Development Review Comments

PAM2024-00151

2101 Gaither Road

PRE-APPLICATION SITE PLAN
PRE-APPLICATION MEETING
PARK PLAZA
ROCKVILLE (4th) ELECTION DISTRICT, MONTGOMERY COUNTY, MARYLAND

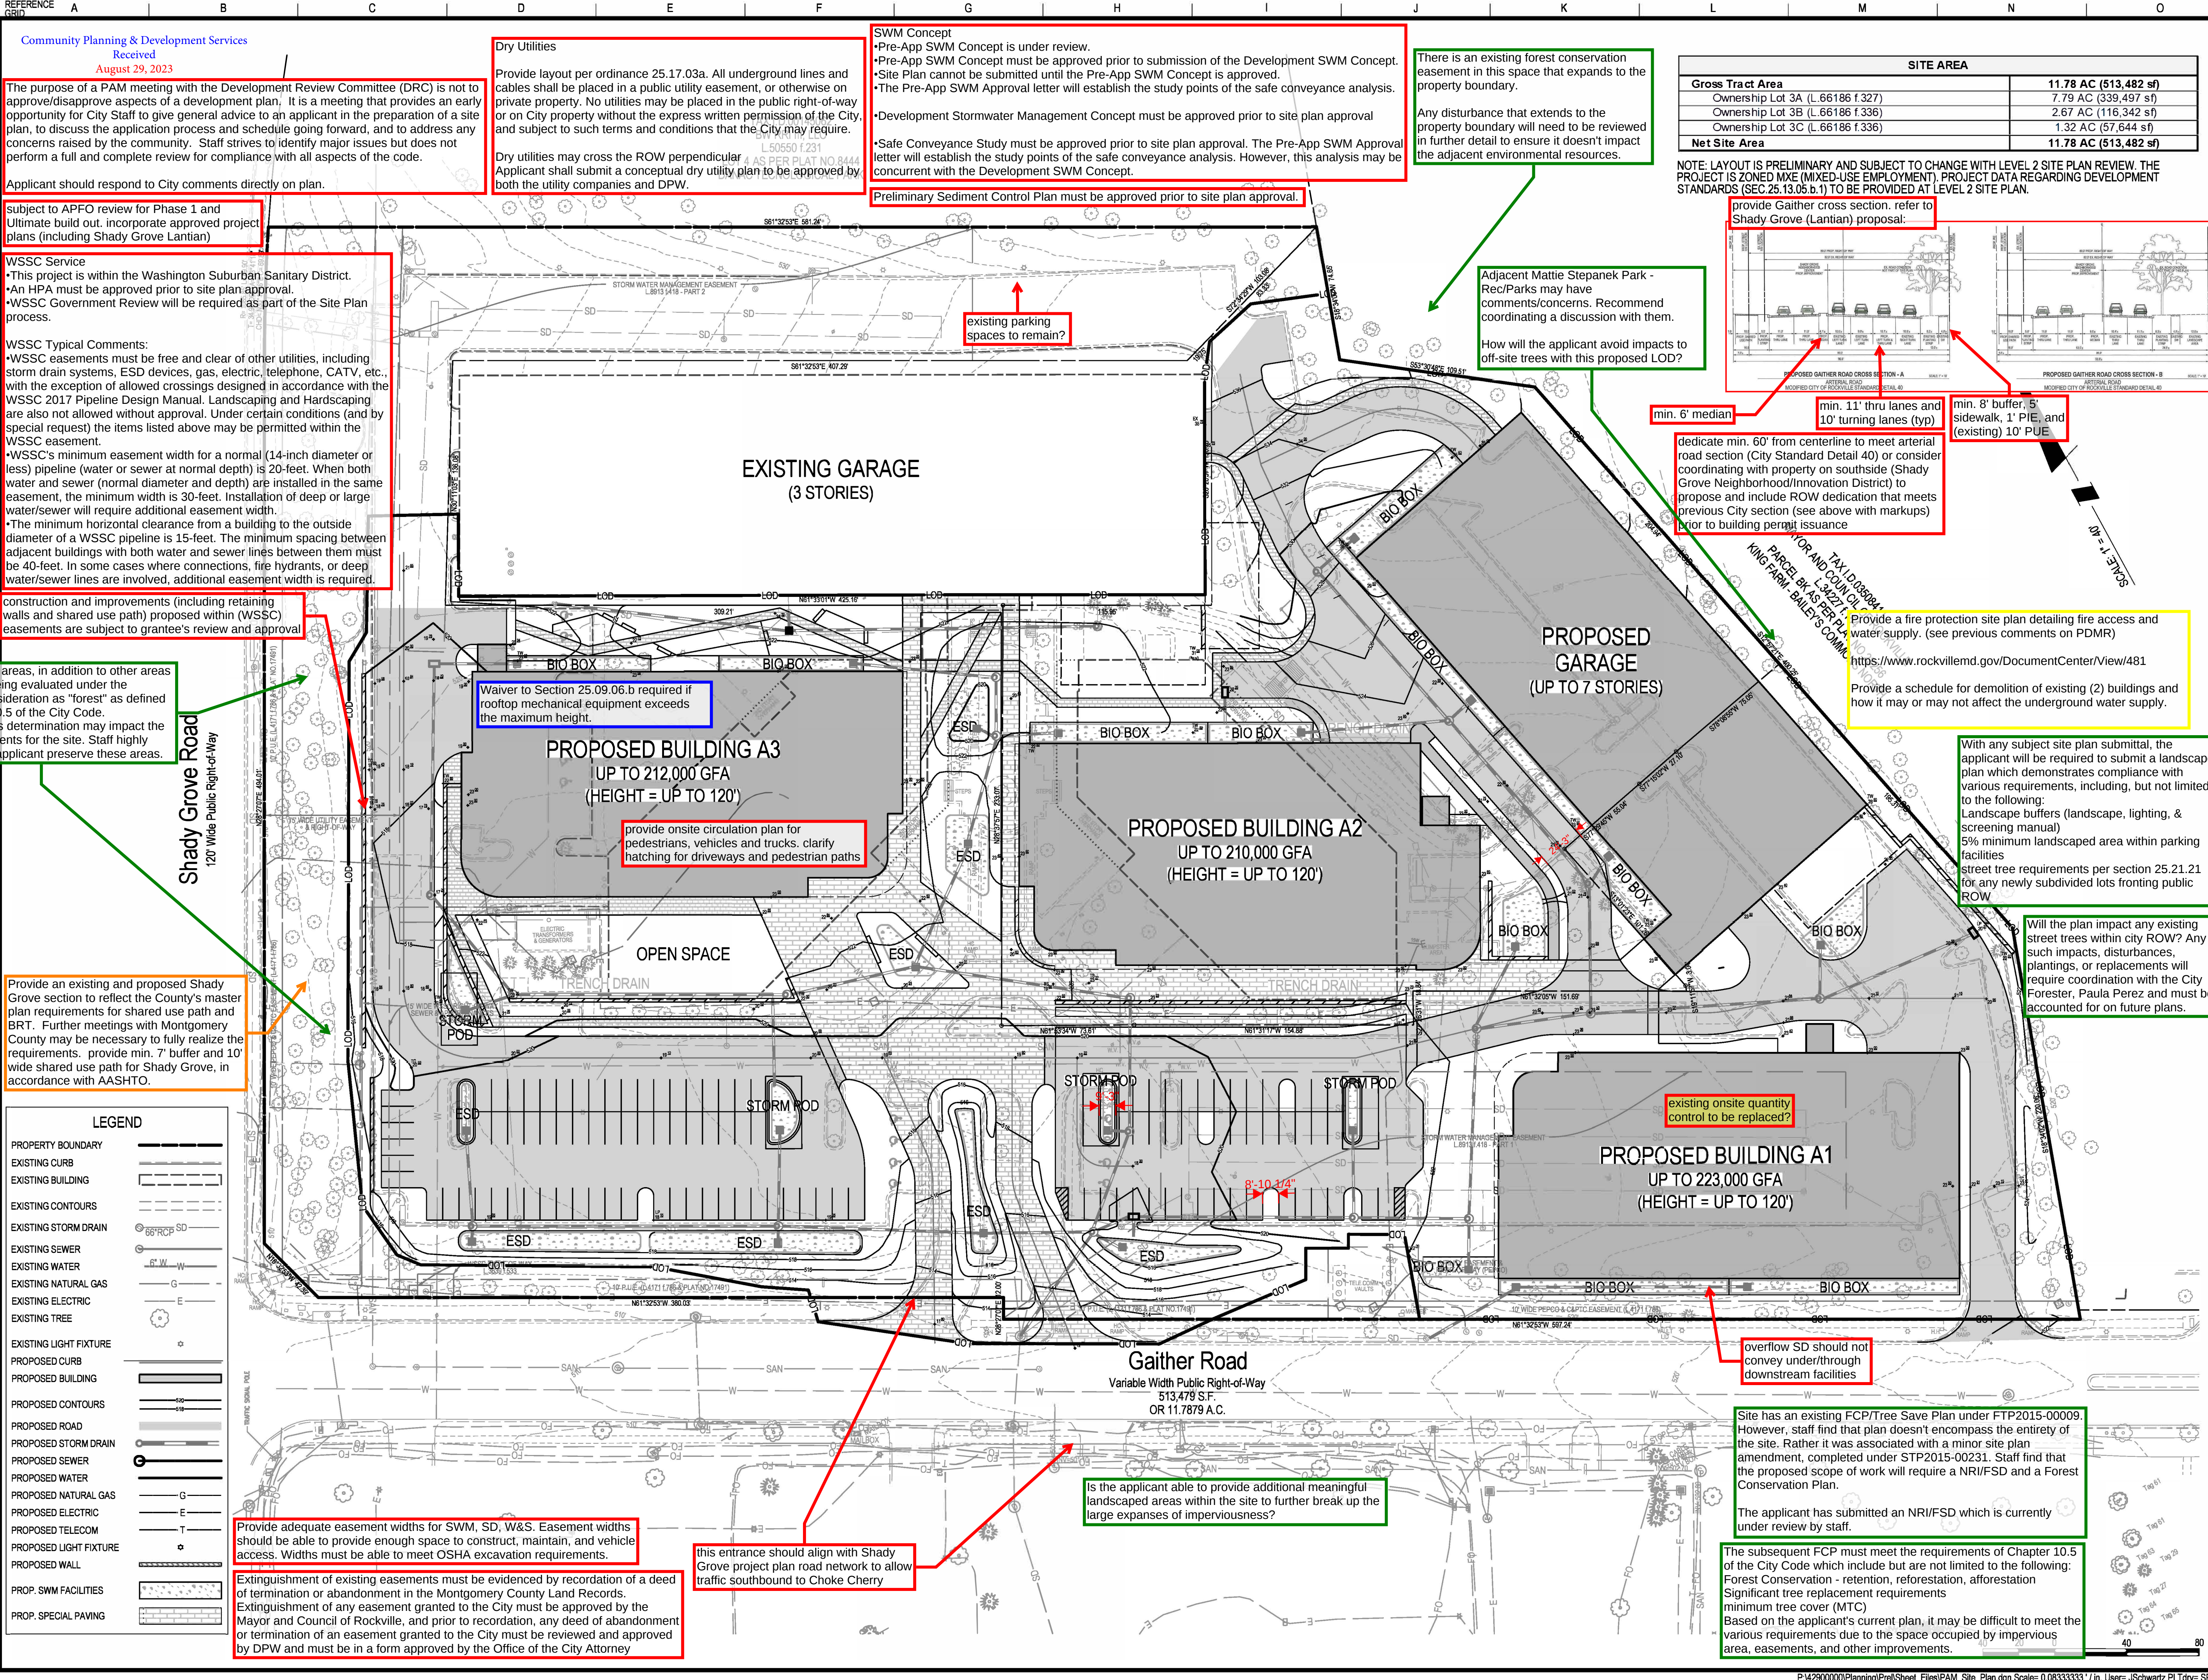
The purpose of a PAM meeting with the Development Review Committee (DRC) is not to approve/disapprove aspects of a development plan. It is a meeting that provides an early opportunity for City Staff to give general advice to an applicant in the preparation of a site plan, to discuss the application process and schedule going forward, and to address any concerns raised by the community. Staff strives to identify major issues but does not perform a full and complete review for compliance with all aspects of the code.

Applicant should respond to City comments directly on plan.

subject to APFO review for Phase 1 and Ultimate build out. incorporate approved project plans (including Shady Grove Lantian)

WSSC Service
•This project is within the Washington Suburban Sanitary District.
•An HPA must be approved prior to site plan approval.
•WSSC Government Review will be required as part of the Site Plan process.

WSSC Typical Comments:
•WSSC easements must be free and clear of other utilities, including storm drain systems, ESD devices, gas, electric, telephone, CATV, etc., with the exception of allowed crossings designed in accordance with the WSSC 2017 Pipeline Design Manual. Landscaping and Hardscaping are also not allowed without approval. Under certain conditions (and by special request) the items listed above may be permitted within the WSSC easement.
•WSSC's minimum easement width for a normal (14-inch diameter or less) pipeline (water or sewer at normal depth) is 20-feet. When both water and sewer (normal diameter and depth) are installed in the same easement, the minimum width is 30-feet. Installation of deep or large water/sewer will require additional easement width.
•The minimum horizontal clearance from a building to the outside diameter of a WSSC pipeline is 15-feet. The minimum spacing between adjacent buildings with both water and sewer lines between them must be 40-feet. In some cases where connections, fire hydrants, or deep water/sewer lines are involved, additional easement width is required.

construction and improvements (including retaining walls and shared use path) proposed within (WSSC) easements are subject to grantee's review and approval

These vegetated areas, in addition to other areas on the site are being evaluated under the NRI/FSD for consideration as "forest" as defined under Chapter 10.5 of the City Code. The results of this determination may impact the forestry requirements for the site. Staff highly recommend the applicant preserve these areas.

Provide an existing and proposed Shady Grove section to reflect the County's master plan requirements for shared use path and BRT. Further meetings with Montgomery County may be necessary to fully realize the requirements. provide min. 7' buffer and 10' wide shared use path for Shady Grove, in accordance with AASHTO.

Dry Utilities
Provide layout per ordinance 25.17.03a. All underground lines and cables shall be placed in a public utility easement, or otherwise on private property. No utilities may be placed in the public right-of-way or on City property without the express written permission of the City, and subject to such terms and conditions that the City may require.
Dry utilities may cross the ROW perpendicular
Applicant shall submit a conceptual dry utility plan to be approved by both the utility companies and DPW.

SWM Concept
•Pre-App SWM Concept is under review.
•Pre-App SWM Concept must be approved prior to submission of the Development SWM Concept.
•Site Plan cannot be submitted until the Pre-App SWM Concept is approved.
•The Pre-App SWM Approval letter will establish the study points of the safe conveyance analysis.
•Development Stormwater Management Concept must be approved prior to site plan approval
•Safe Conveyance Study must be approved prior to site plan approval. The Pre-App SWM Approval letter will establish the study points of the safe conveyance analysis. However, this analysis may be concurrent with the Development SWM Concept.
Preliminary Sediment Control Plan must be approved prior to site plan approval.

There is an existing forest conservation easement in this space that expands to the property boundary.
Any disturbance that extends to the property boundary will need to be reviewed in further detail to ensure it doesn't impact the adjacent environmental resources.

Adjacent Mattie Stepanek Park - Rec/Parks may have comments/concerns. Recommend coordinating a discussion with them.
How will the applicant avoid impacts to off-site trees with this proposed LOD?

min. 6' median
dedicate min. 60' from centerline to meet arterial road section (City Standard Detail 40) or consider coordinating with property on southside (Shady Grove Neighborhood/Innovation District) to propose and include ROW dedication that meets previous City section (see above with markups) prior to building permit issuance
min. 11' thru lanes and 10' turning lanes (typ)
min. 8' buffer, 5' sidewalk, 1' PIE, and (existing) 10' PUE

Provide a fire protection site plan detailing fire access and water supply. (see previous comments on PDMR)
<https://www.rockvillemd.gov/DocumentCenter/View/481>
Provide a schedule for demolition of existing (2) buildings and how it may or may not affect the underground water supply.

With any subject site plan submittal, the applicant will be required to submit a landscape plan which demonstrates compliance with various requirements, including, but not limited to the following:
Landscape buffers (landscape, lighting, & screening manual)
5% minimum landscaped area within parking facilities
street tree requirements per section 25.21.21 for any newly subdivided lots fronting public ROW

Will the plan impact any existing street trees within city ROW? Any such impacts, disturbances, plantings, or replacements will require coordination with the City Forester, Paula Perez and must be accounted for on future plans.

Provide adequate easement widths for SWM, SD, W&S. Easement widths should be able to provide enough space to construct, maintain, and vehicle access. Widths must be able to meet OSHA excavation requirements.
Extinguishment of existing easements must be evidenced by recordation of a deed of termination or abandonment in the Montgomery County Land Records. Extinguishment of any easement granted to the City must be approved by the Mayor and Council of Rockville, and prior to recordation, any deed of abandonment or termination of an easement granted to the City must be reviewed and approved by DPW and must be in a form approved by the Office of the City Attorney

this entrance should align with Shady Grove project plan road network to allow traffic southbound to Choke Cherry

Is the applicant able to provide additional meaningful landscaped areas within the site to further break up the large expanses of imperviousness?

Site has an existing FCP/Tree Save Plan under FTP2015-00009. However, staff find that plan doesn't encompass the entirety of the site. Rather it was associated with a minor site plan amendment, completed under STP2015-00231. Staff find that the proposed scope of work will require a NRI/FSD and a Forest Conservation Plan.
The applicant has submitted an NRI/FSD which is currently under review by staff.

The subsequent FCP must meet the requirements of Chapter 10.5 of the City Code which include but are not limited to the following:
Forest Conservation - retention, reforestation, afforestation
Significant tree replacement requirements
minimum tree cover (MTC)
Based on the applicant's current plan, it may be difficult to meet the various requirements due to the space occupied by impervious area, easements, and other improvements.

Table 1
2102 Gaither Road
Site Trip Generation (1)

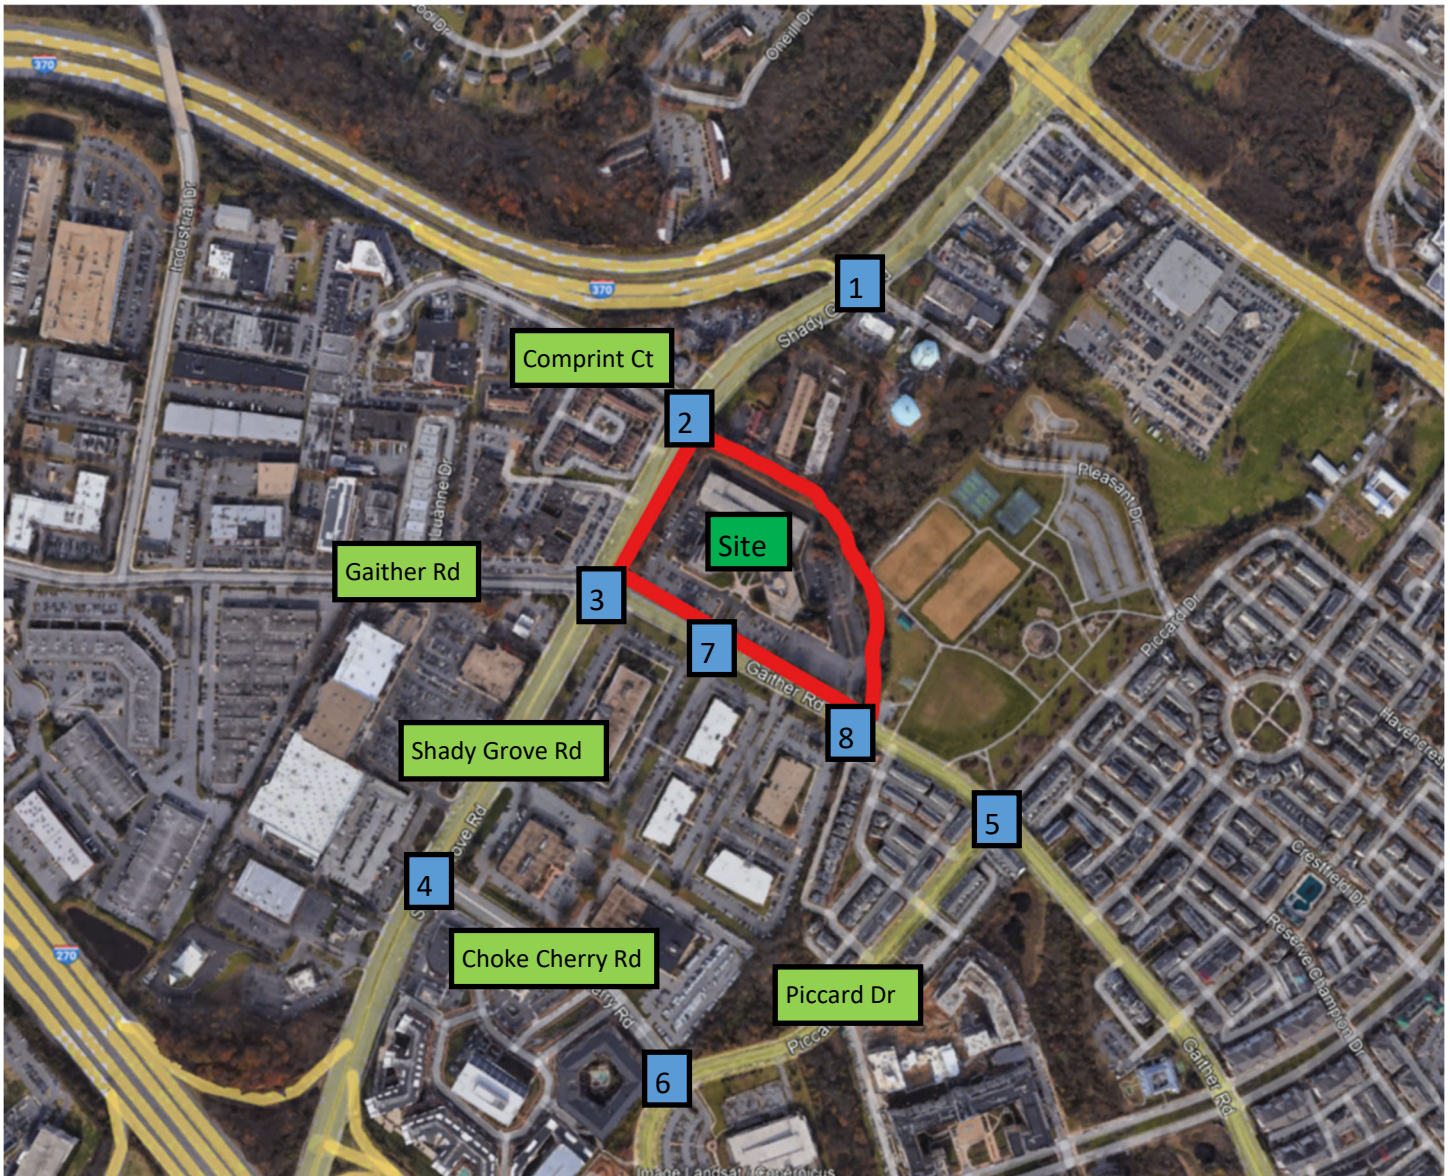
Please provide detailed trip calculations for phase 1, which include the existing 260, 000 SF of office and the amount of proposed new R&D development that will be constructed with Phase 1, and any other development phase as well as for the ultimate buildout.

Complete and detailed analysis needed for each phase as well as the build out condition. For the background all prior approved development applications that are not fully occupied with the study area (min. radius of 0.35 miles) must be included. For each phase and build out the assumed transportation network may include all programmed with 100% funded for construction improvements as well as any improvements required of already approved developments. This also means the T&T recommended approval conditions for the proposed plan would call for provision of the same improvements.

As required by the CTR and in addition to a revised scoping intake form, please submit for review a detailed technical approach and methodology report and include detailed trip distribution (% and trips) for each phase and for each background development that are based on the patterns included in the approved transportation study or are determined using the most recent M-NCPPC regional trip tables. please make sure to show the needed information using maps and figures that include all identified intersections within the study area. Please also note, the required CTR review fee based on the number of intersections identified in this draft scoping form, is \$7000.

As required by CTR, staff recommends Sat peak hour analysis for for all identified intersections in addition to weekday AM and PM peak hours. staff also recommend as required special studies, submittal of detailed peak hour queue analysis for the existing, and projected left turning traffic volumes from Gaither Road to shady Grove and full traffic signal warrant study for the intersection of Gaither Road and the site's north site access road.
